## Right-Energy Review Notes

This document includes the results of limited testing and verification of the Rightsoft software submitted as a simulation tool for demonstrating compliance with Section 405 of the 2014 FL Building Code, Energy Conservation. The testing was limited to some of the basic requirements due to time constraints and did not fully cover all aspects of the 2014 FL Building Code or the TAM.

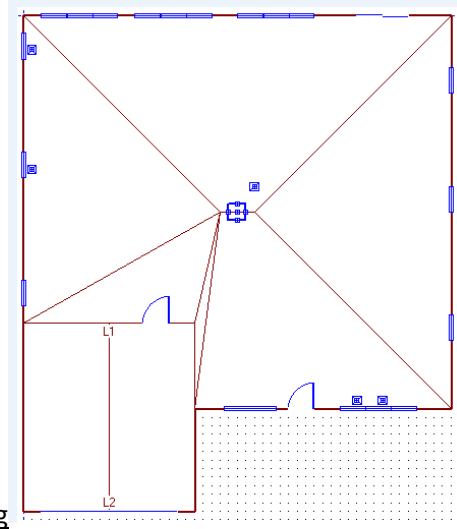
- First page of Form 405-2014 vs. subsequent pages discrepancies (from Right-Energy Florida 2014 Example file). The discrepancies include:
  - o Ceiling R-value 30 on first page vs. 31 on subsequent pages

- o Multiple walls indicated on first page vs. only one wall on subsequent pages
  - o Multiple windows indicated on first page vs. only one window on subsequent pages

- o Wall cavity R-values 19 and 15 on first page vs. 0 on subsequent pages
  - o Number of bedrooms = 3 on first page vs. 0 on subsequent pages
  - o Cooling system SEER 14 on first page vs. EER 10.6 on subsequent pages

- o Hot Water system solar with FEF 7 on first page vs. non-solar with EF 0.96 on subsequent pages
  - o Hot Water system capacity 120 gal. on first page vs. 40 gal. on subsequent pages

- o Duct R-value 8 on first page vs. 6 on subsequent pages
  - o "Attic ceiling" on first page vs. "No attic" on subsequent pages.
- The Attic section indicates "No attic" and "Unvented" but also has a vent ratio of 1 in 300, while the Ducts section shows the duct location as being "Vented attic."

Software input - multiple windows on drawing

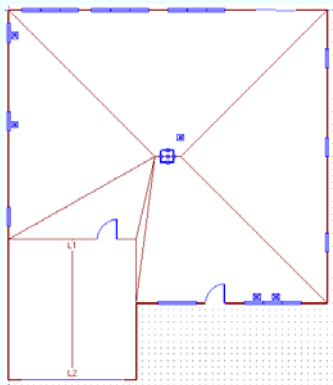
-Software input for windows indicates multiple windows and does not match Form R405 which indicates a single window
